Plan and Architectural Review Commission Meeting Agenda
City of Whitewater Municipal Building
Community Room- First Floor
312 W. Whitewater St.
Whitewater, WI 53190
June 12, 2023 at 6:00 p.m.

Re: Item 5: Site plan review and possible approval for a proposed commercial building located at the northeast corner of North Prospect and Endeavor Drive, parcel number 292-0515-3434-003, for Larry Chapman, owner.

Re: Item 7: Site plan review and possible approval of a proposed grocery store located at 1380 W. Main Street, Parcel #/WUP 00159, for DLK Farm Service.

SHEET NO.
C200

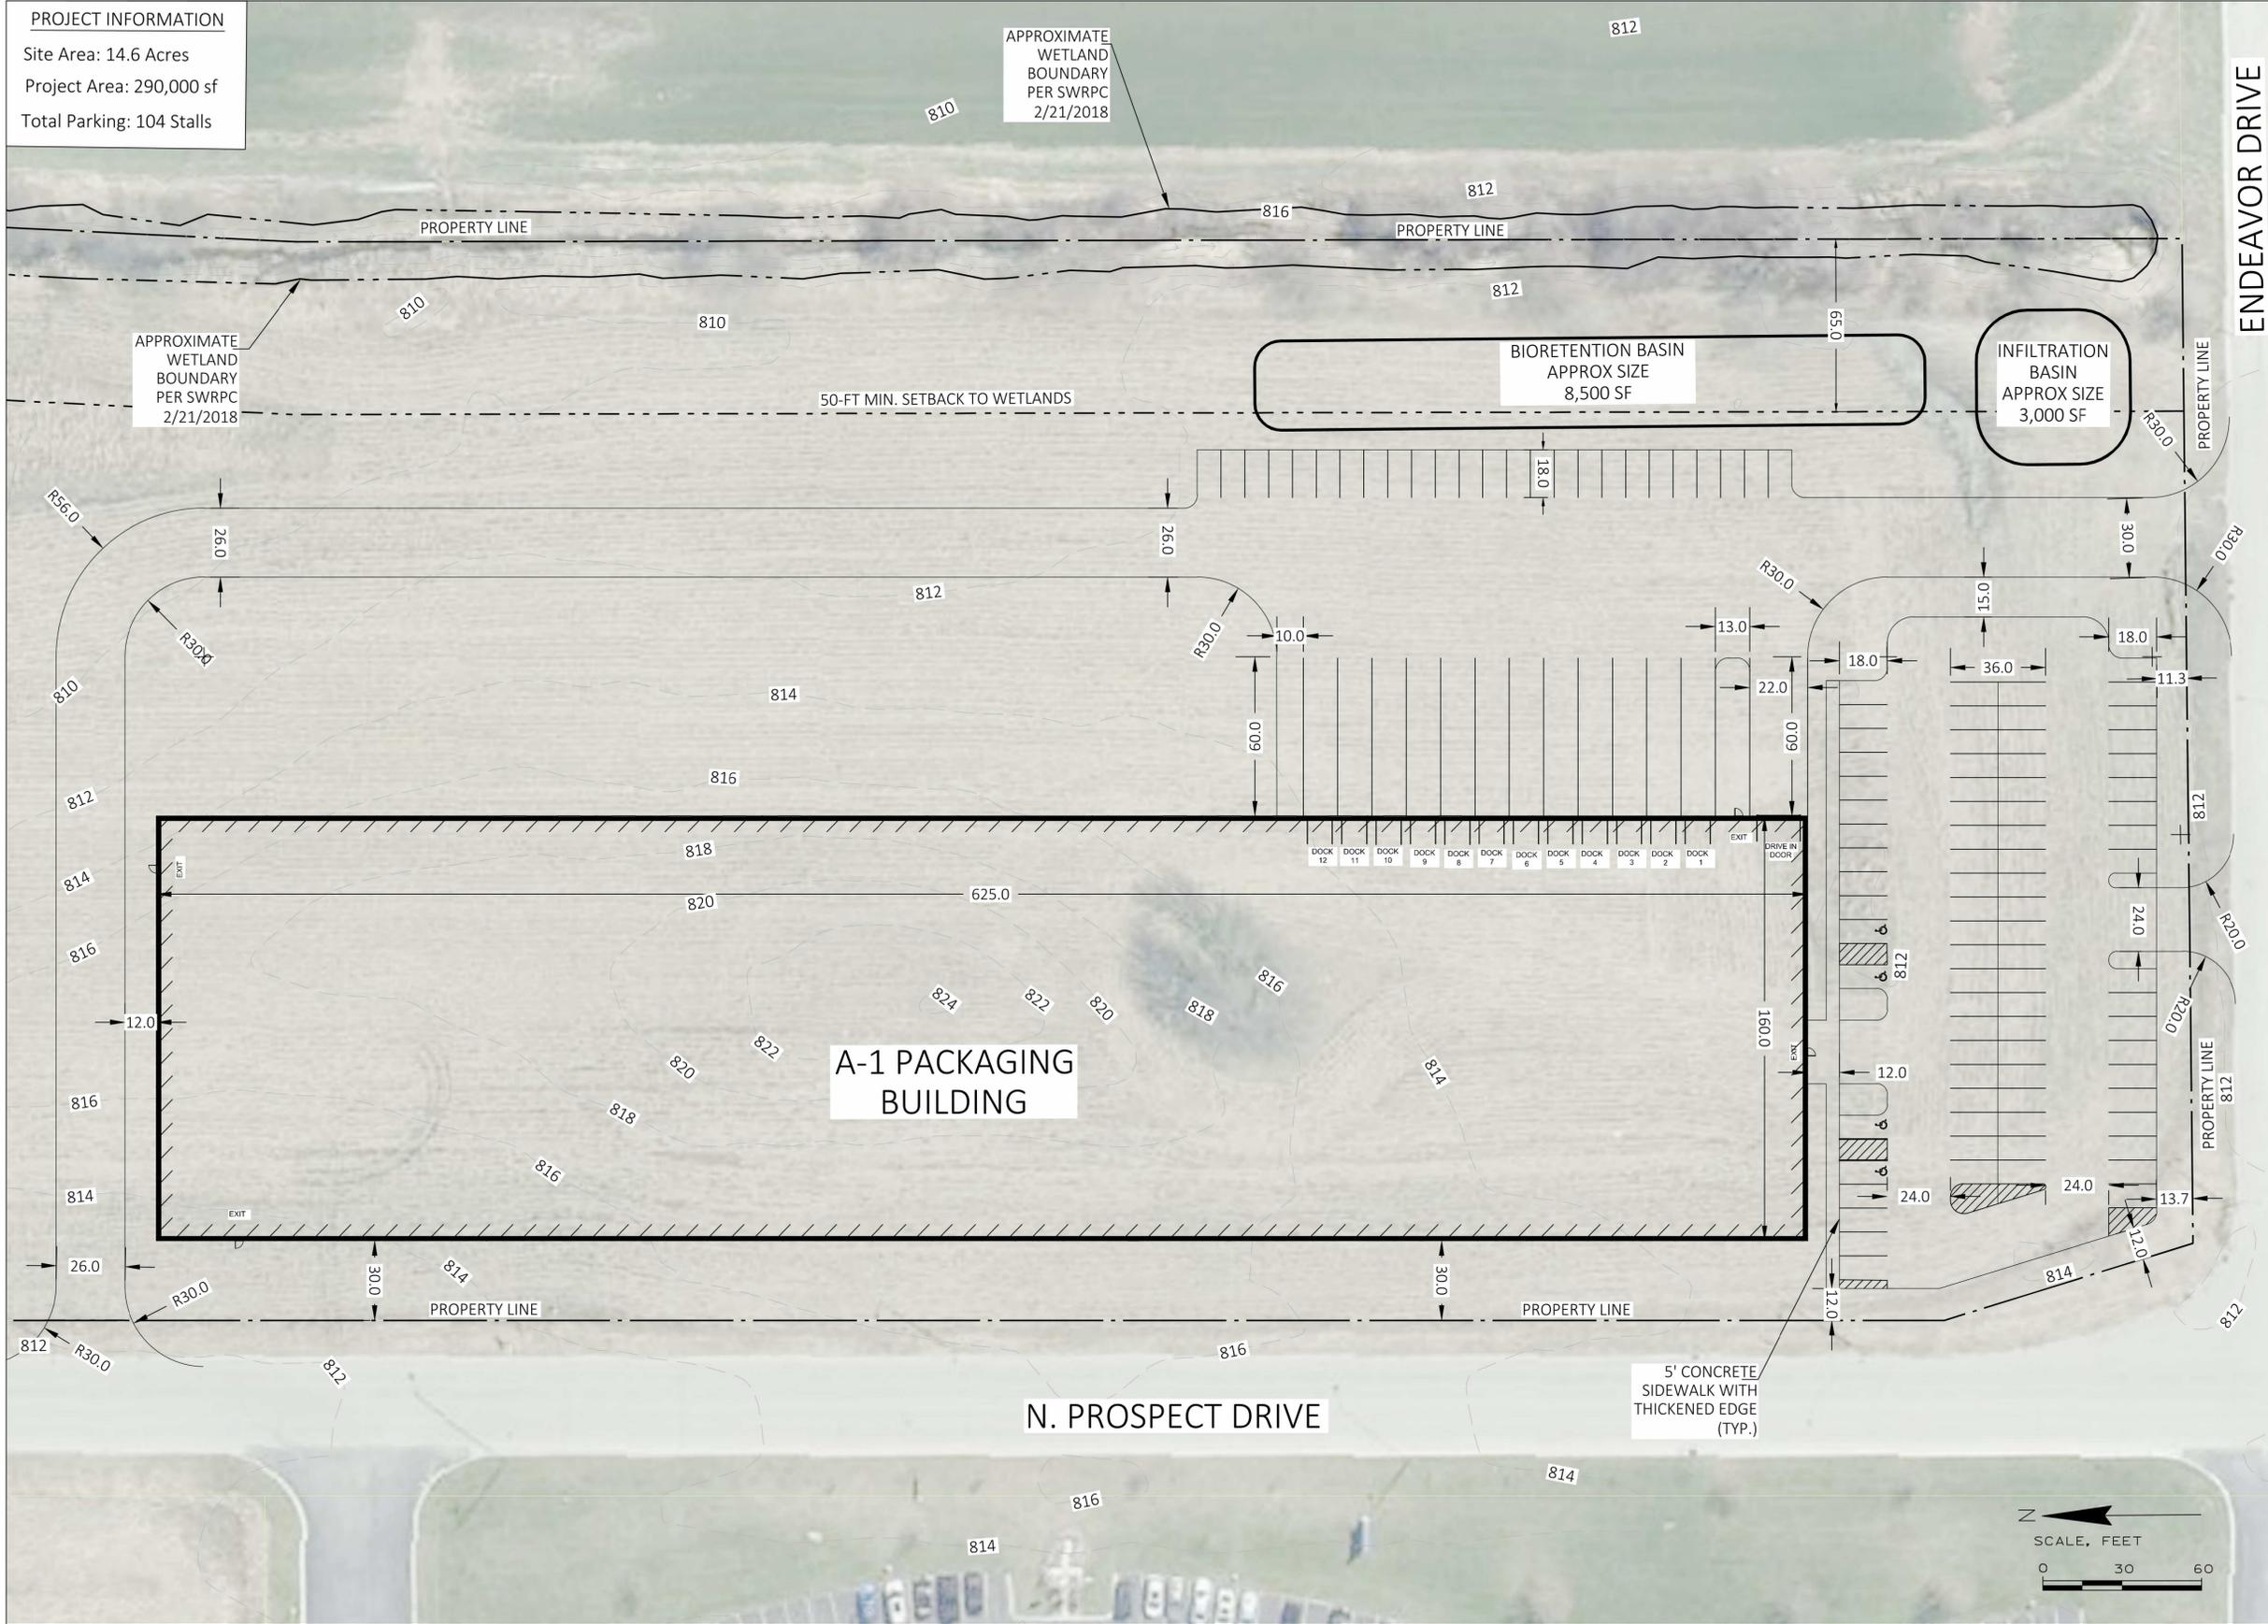
- Per 19.51.130, there must be one stall for each 2 employees working per shift for manufacturing and processing plans, laboratories and warehouses. Chapman said about 50 employees are working at the plan at any one time.
- 99 spots, plus four ADA spots, are shown.
- The building either needs to move roughly two feet or the developer needs to be put some sort of natural buffer in between the parking lot and property line, per 19.51. City staff will work with the developer on this matter.

- There is no minimum requirement for landscaping in M-1. No landscaping plan is provided – review by Urban Forestry Committee is recommended once a plan is provided. Developer and construction company are aware.

- Developer must provide a lighting plan, and the plan must be reviewed and approved by staff.
- Developer must provide a landscaping plan, and the plan must be reviewed and approved by staff

PHO1.1

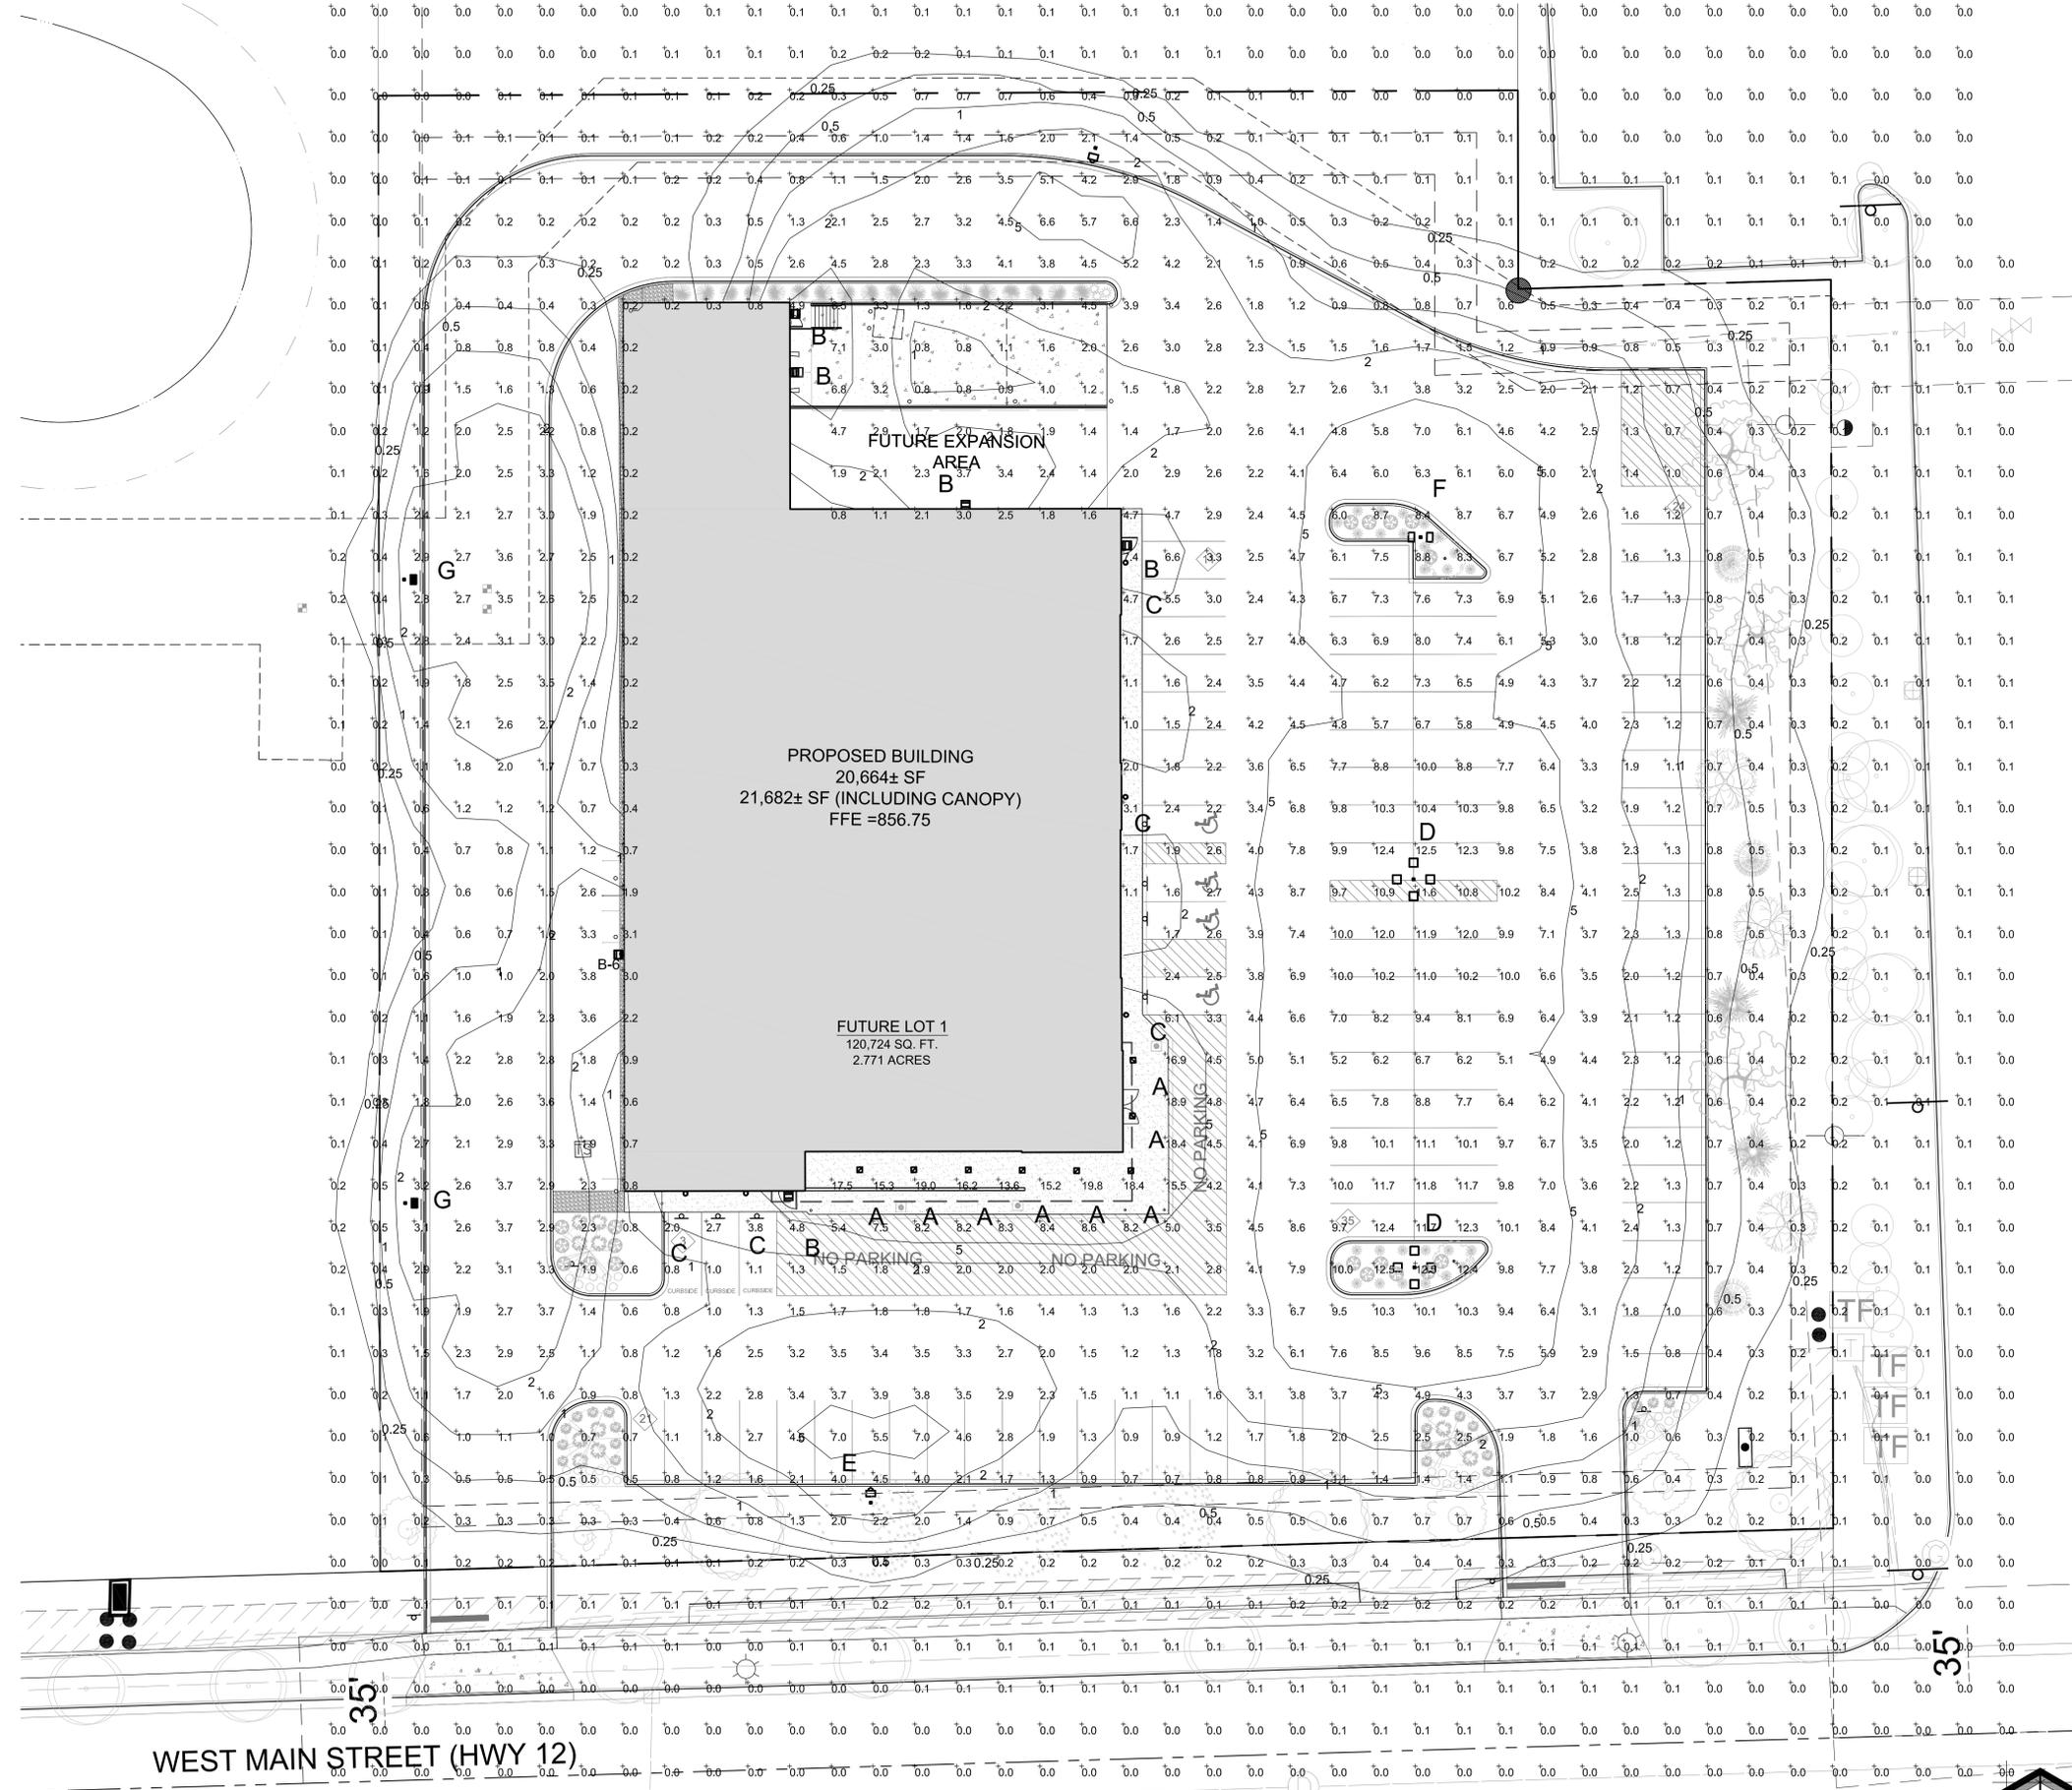
- PHO 1.1 provides the photometric plan. Height of light fixtures should be verified.
- Average illumination levels within parking lots shall not exceed 2.5 footcandles. The illumination level at any property line shall not exceed 0.5 footcandles above the ambient lighting conditions on a cloudless night where the property adjoins land in a residential district, and 2.0 footcandles above the ambient lighting conditions on a cloudless night where the property adjoins land in any other zoning district. Per PHO 1.1, all average illumination levels are within standards.
